<b>Docket Number:</b>	14-AAER-02
<b>Project Title:</b>	Computer, Computer Monitors, and Electronic Displays
<b>TN #:</b>	205736
<b>Document Title:</b>	California Investor Owned Utilities Comments: CA IOUs & NRDC August 2015 CASE Response to CEC proposal
<b>Description:</b>	N/A
<b>Filer:</b>	System
<b>Organization:</b>	California Investor Owned Utilities
<b>Submitter Role:</b>	Public
<b>Submission Date:</b>	8/14/2015 8:58:36 AM
<b>Docketed Date:</b>	8/14/2015

**CA IOUs & NRDC August 2015 CASE Response to CEC proposal**

Response to CEC Standards Proposal for  
**Computers**

Docket #14-AAER-2A

**Figure 3.1 Average Display Allowances Across QPL for May 2014 - April 2015 Models - Standard Display**

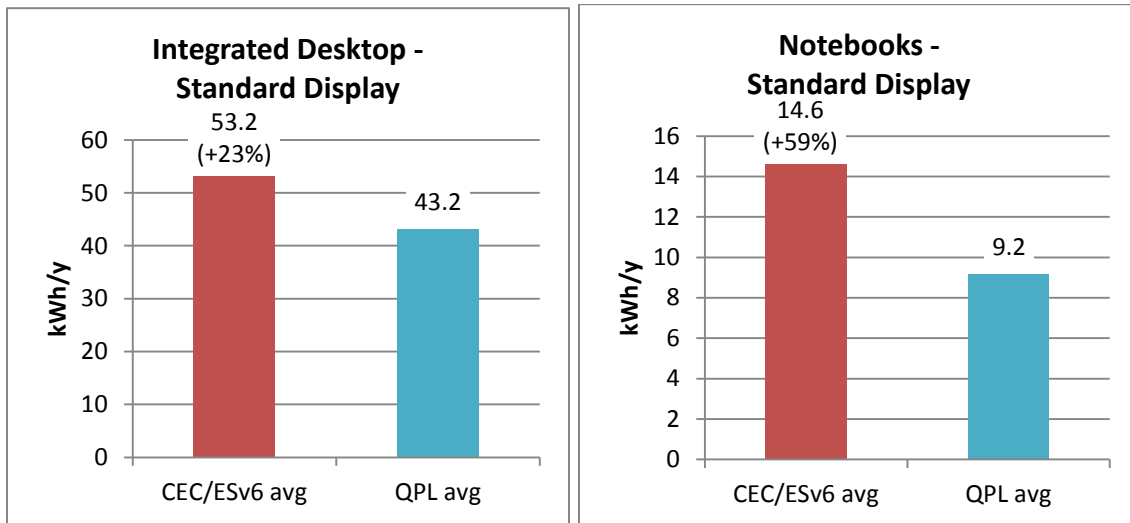
Figure 3.1 shows that CEC proposed adders, based on ENERGY STAR v6, are on average 23% higher than the difference between short and long idle in the QPL for integrated desktops, and 59% higher for notebooks.

These differences have a huge impact on the effectiveness of the standards, because display allowances are of the same order of magnitude as the base allowance for the system: 53 vs. 50 kWh for integrated desktops, 15 vs. 30 for notebooks. In a TEC approach where excessive adders can

give inefficient systems a free pass to comply, it is critical to pay attention to adders like displays so that the overall cost-effective and feasible energy savings are optimized.

Figure 3.2: Comparison of Advocate Display Adder Proposal vs. CEC/ENERGY STAR v6.1 and QPL (May 14–April 15) – Standard Display

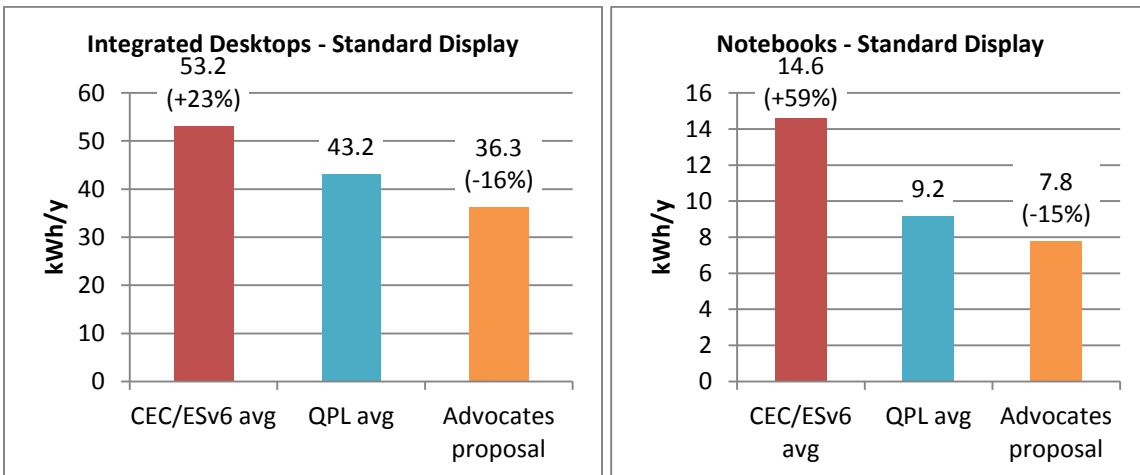
Figure 3.2 shows how these proposed levels compare with ENERGY STAR v6.1 and with the QPL on average.

Our proposed levels yield “pass rates” of 21% of the QPL for integrated desktops (54% for Enhanced Performance Displays, or EPDs), and 29% for notebooks (44% for EPDs) as shown in Table 3.1. The substantial number of units achieving these levels demonstrates their technical feasibility and broad availability in the market today. Note that these are not real pass-rates; we’re using conservative estimates of display power.

We propose revised display adders that are closer to the real needs of recent computers in the ENERGY STAR QPL. Our proposal is approximately 15% lower than the average difference between short and long idle power in the QPL for computers registered with ENERGY STAR from May 2014 to April 2015 (in order to represent the latest technology, which will be mainstream by 2017 / 2018). We have chosen a value that is lower than the average, because the difference between short and long idle can include more than just display power. For example, it could also include power savings from placing the disk and other components in lower power modes in long, and to some extent, short idle.

Our proposal uses a hyperbolic tangent equation, similar to that proposed in ENERGY STAR display spec Version 7 draft 2:

Computer type	Display allowance (kWh/year)
<b>Integrated desktops</b>	$8.76 \times 0.35 \times (1+EP) \times (0.5 \times r + 16 \times \text{Tanh}(0.004 \times (A-55) + 0.25) + 0.3)$
<b>Notebooks</b>	$8.76 \times 0.3 \times (0.25 \times r + 8.5 \times \text{Tanh}(0.003 \times (A-70) + 0.22) + 0.3)$

**Figure 3.7: IOU, NRDC and CLASP measurements of dGfx, 2011 – 2015, with linear trends. Data collected in 2014 and 2015 were combined for the trend shown in gray.**

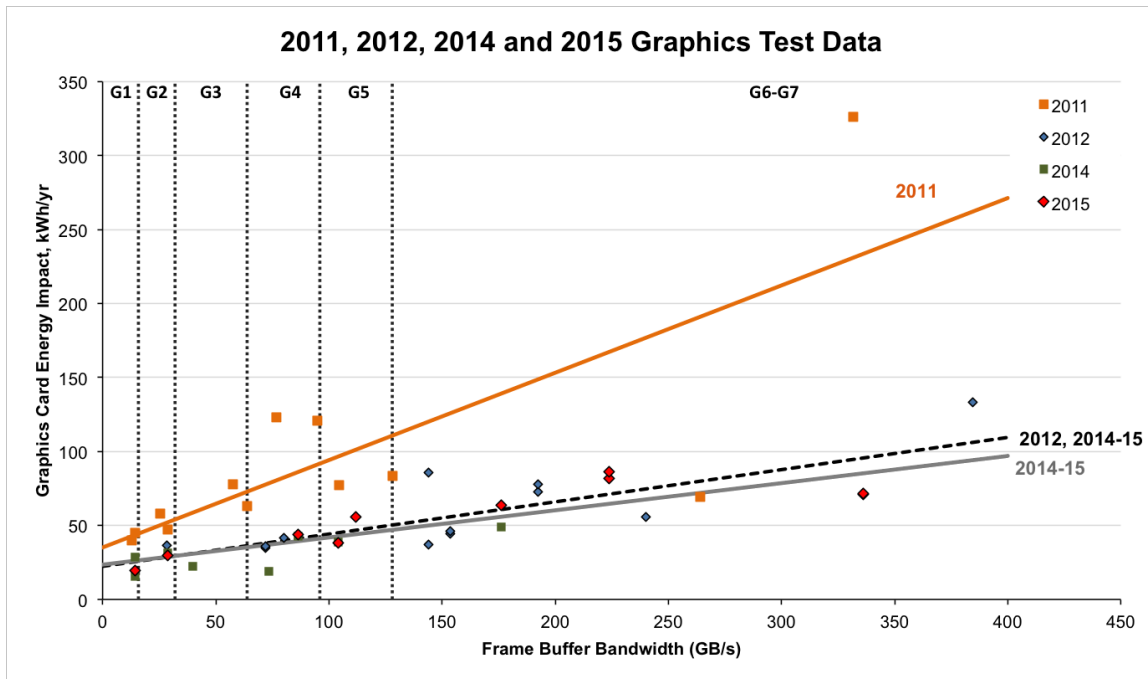
GPU manufacturers have dramatically improved the efficiency of their products in the past half-decade. Until 2011, many discrete GPU products consumed as much energy as a mainstream desktop computer itself. Today, thanks to process improvements and enhanced power management, even the highest specification cards have power demands less than 10 W (DC) during

idle modes (Tom’s Hardware, 2015). Since 2011, the CASE team, along with CLASP and NRDC, has been developing a dataset of discrete GPU power measurements (37 dGfx in all) and have observed a stepped decrease in energy consumption. Figure 3.7 illustrates the incremental TEC impacts of a broad sampling of dGfx, displayed as a function of Frame Buffer Bandwidth (FBB) in GB/s (a proxy for overall card performance and graphics throughput). The chart also displays the FBB limits of each ECMA performance category. In 2011, a typical G4 dGfx contributed an additional 102 kWh/yr to a desktop’s TEC, but now only adds 35 kWh/yr, a 66% decline.

Figure 3.10: Proposed Tier I adder for discrete graphics-only systems.

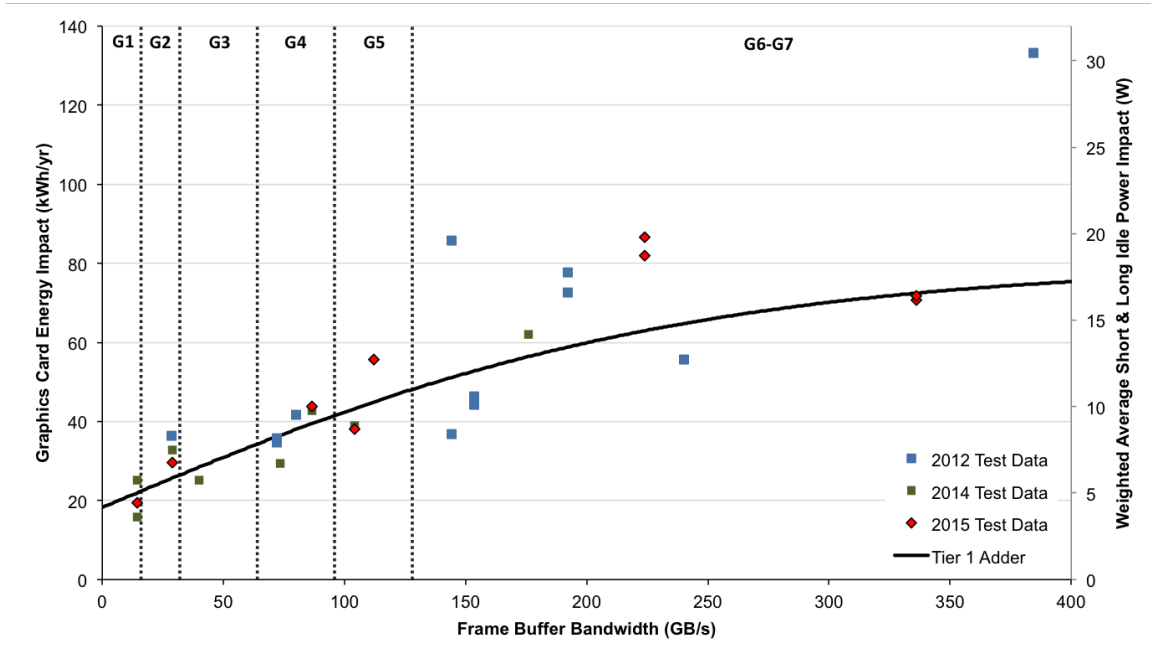
[Note that here Z = 0] About 44% of the discrete GPUs tested by the IOUs in 2012, 2014, and 2015 pass the proposed Tier I adder (Figure 3.10).

The proposed Tier I adder includes many products available on the market today across every performance category:

$$TEC_{dGPU} = 65 * \tanh(0.004 * FBB + 0.05) + 15$$

**Figure 3.11: Proposed Tier II adder for discrete graphics-only systems.**

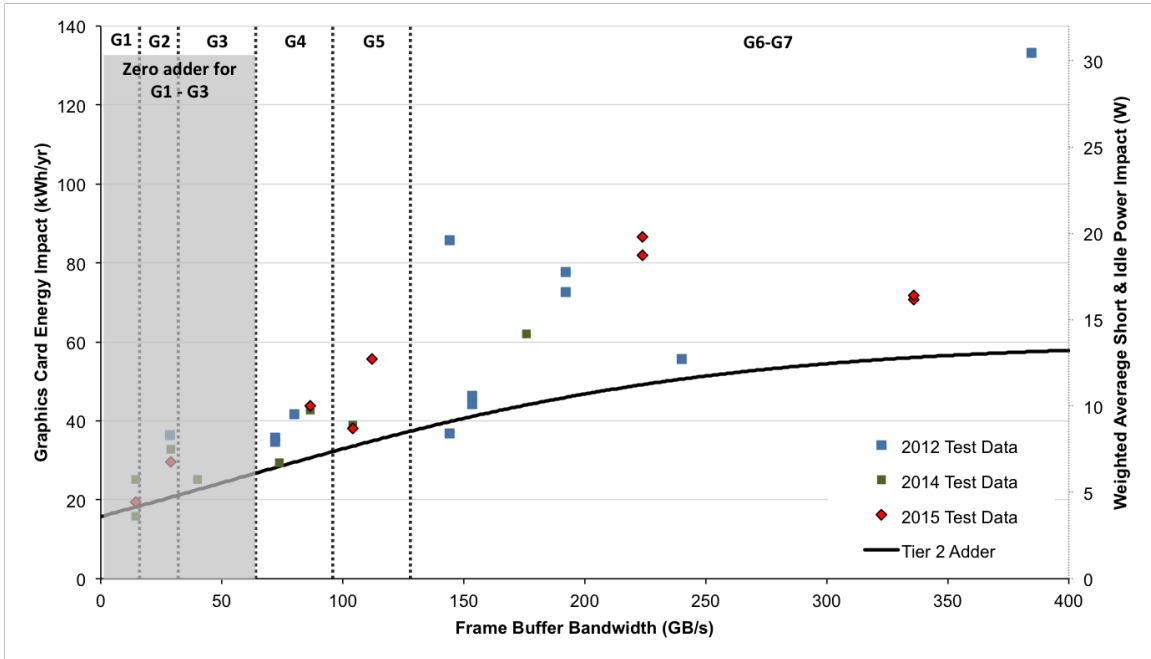
Currently, only 2 of our measured GPUs would pass the proposed Tier 2 adder. However, if the discrete GPUs tested in the 2012, 2014, and 2015 projects achieved the 95% lower long idle power, 24% of them would pass the proposed level.

The Tier II proposal is based on two technologies that have already been implemented in a limited number of discrete GPUs and systems, but will likely be mainstream by the effective date of Tier II in 2019 (assumed to be one year after the effective date of Tier I). The first is reducing discrete GPU power in long idle mode when the monitor is blank, as implemented in AMD’s ZeroCore Technology. AMD claims that this type of power management can reduce long idle power of the GPU by at least 95%<sup>9</sup>. We generated the proposed Tier II curve by applying a 95% drop in long idle power on the 2014 and 2015 data, and constructing a curve that allows GPUs to pass across performance categories (Figure 3.11):

$$TEC_{dGPU} = 35 * \tanh(0.005 * (FBB - 64) + 0.05) + 25$$

**Figure 3.12: Incremental TEC consumed by desktop computers with additional installed memory. Source: ENERGY STAR qualifying products list, 2015**

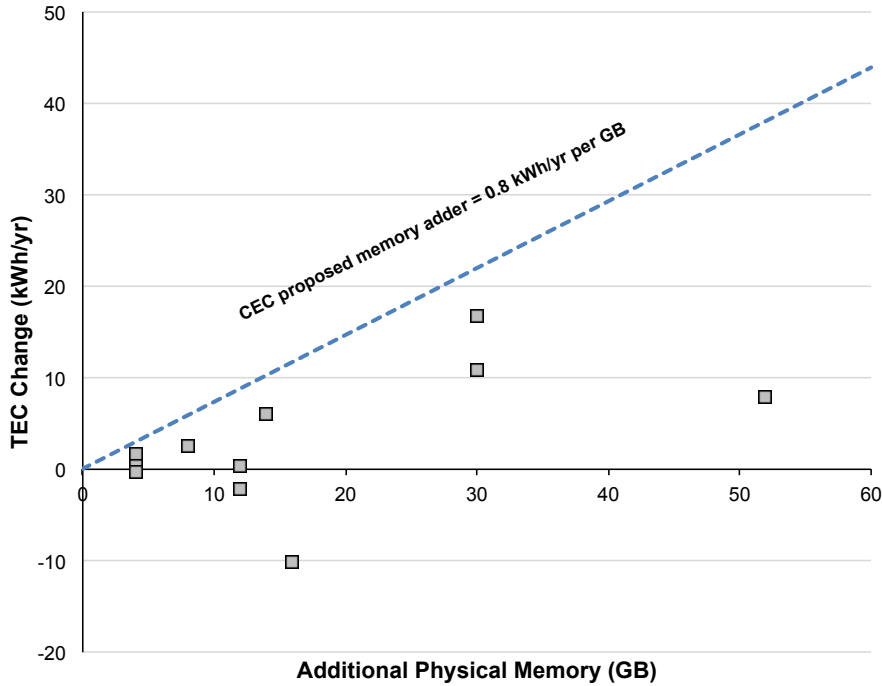
Even compared to today’s designs using DDR3 memory, the staff proposal is too conservative for establishing an energy efficiency standard. The CASE Team has identified computer models on the ENERGY STAR QPL with identical model numbers and equivalent (or occasionally higher performance) processors, but differing amounts of physical memory, allowing for a comparison of real memory TEC impacts. As Figure 3.12 shows, the total amount of installed physical memory is a relatively poor indicator of energy use and, therefore, should not be used as a basis for granting

functional allowances.<sup>10</sup> Furthermore, the proposed 0.8 kWh/yr per GB value is overly conservative and can grant over 50 kWh/yr of additional TEC to high-end systems (twice that amount as 16 GB DIMMs become available, enabling 128 GB memory installs in high-performance systems).

Recent testing conducted by Aggios suggests that the incremental power consumed by memory tends to scale more closely with the number of populated dual inline memory module (DIMM) slots on the motherboard than with overall capacity. Aggios’ testing also shows that memory typically consumes about 1.3 to 2.2 kWh/yr per installed DIMM, based on today’s DDR3 technology.

The CASE Team proposes an alternative memory adder informed by Aggios’ testing and our current understanding of memory energy usage. Our proposal grants no adder for the first DIMM installed in the system (its energy use is covered by the base TEC allowance), but provides a 2 kWh/yr adder for each additional installed DIMM. Mathematically expressed, this is

**Figure 5.1: Percent increase in TEC under real-world test conditions compared to ENERGY STAR measured TEC**

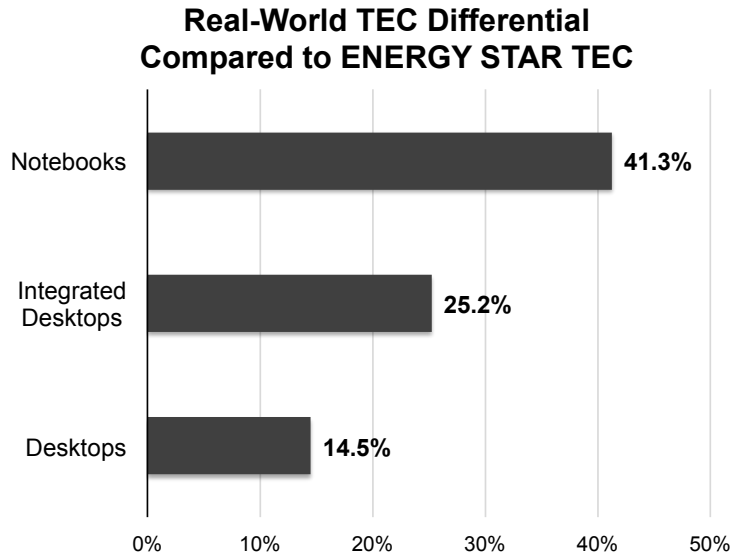
The CASE Team has been examining the impacts of real-world usage on computer energy use since mid-2014 and has generally found that ENERGY STAR-reported TEC values need to be adjusted to determine actual energy use in the field. We provided initial results of this research as part of our October 2014 CASE report addendum (CA IOUs 2014). Our most recent analysis shows that computers can consume anywhere from 15 to 40% more energy under real-world conditions compared to ENERGY STAR-reported TEC (see Figure), not including the duty cycle adjustment discussed above. As discussed in earlier comments, such adjustments for field usage could increase energy savings for the same cost, and therefore increase cost effectiveness for the proposed standard. We recommended CEC use a TEC adjustment factor in its analyses. Specifically, we recommend adopting the adjustments presented in Figure with a 50% weighting. Accordingly, this would mean an adjustment of 7.25% for desktops, 12.5% for integrated desktops, and 20.5% for notebooks.

**The CASE Team proposes that CEC utilize our latest published TEC<sub>adjustment</sub> factors (Figure) with a 50% weighting when applying them to energy savings and cost effectiveness estimates.**

Figure 6.1: Efficiency Profiles of 80 PLUS GOLD Power Supplies

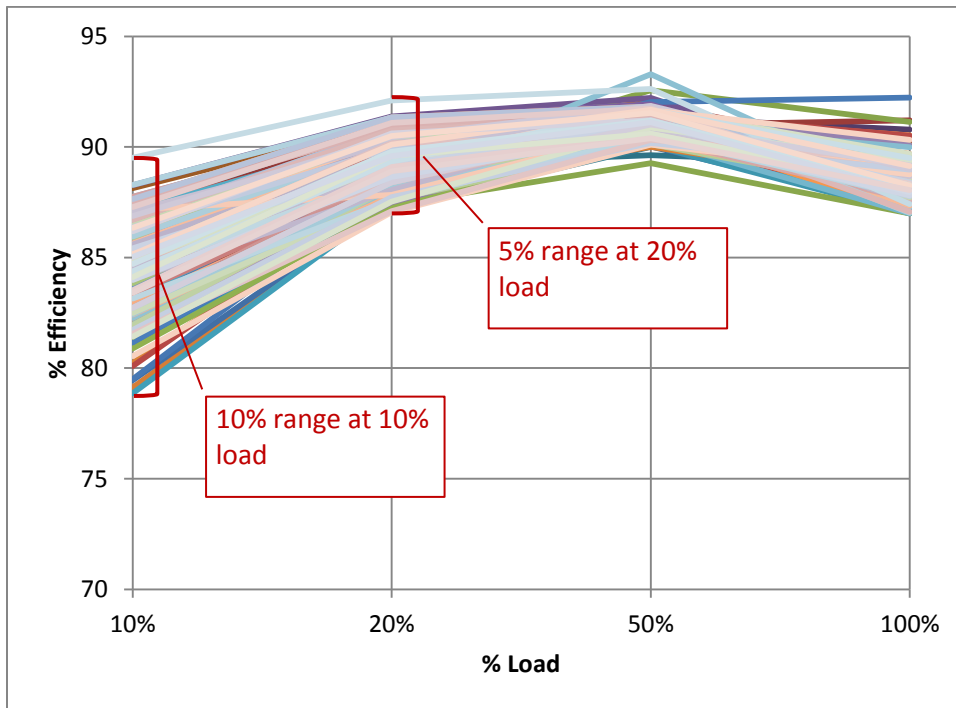
Unfortunately, the 80 PLUS standard test points of 20, 50 and 100 load focus on the active load range, and do not guarantee a decent efficiency below 20 percent. An 80 PLUS power supply with poor efficiency at the idle load point, would significantly impact overall system efficiency.

In fact, the 80 PLUS program has been testing all power supplies at the 10 percent load point since January 2012, despite this load point not being part of the 80 PLUS standard. The test data is available on the 80 PLUS website<sup>15</sup>. An analysis of this data in Figure 6.1 shows that the range of efficiencies is twice as large at 10 percent as at 20 percent load, confirming that the 10 percent load range is not consistently optimized.

This requirement does not significantly add to the test burden for manufacturers, since the 10 percent load test can be performed using the same test setup and equipment as other load points, adding negligible time and cost to the 80 PLUS testing.
